# MCU

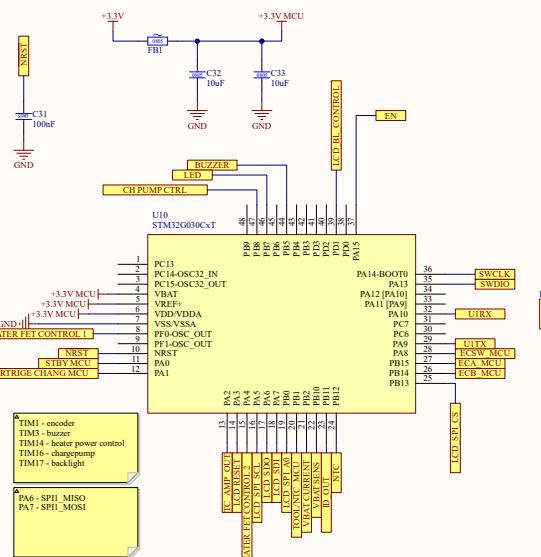
Poprzedni Pullup and pulldown o rezystancji 1M są zbyt duże. Powinny zostać zamienione na 470k.

Konfiguracja pinów od UART nie jest odwrotna. ST-LINK nie trzyma się konwencji, że RX->TX. Litera T przy oznaczeniu odnosi się do mikrokontrolera. Cyfry VCP\_TX powinno być podłączone pod wejście TX po stronie MCU. Mikrokłose porówna na owagpin pinów RX i TX.

Brak diody rozładującej indukcyjność buzzera. Na oscylogramie widak napięcie skacze na dźwięk transystora Q13, do wartości która mogłaby go uszkodzić.
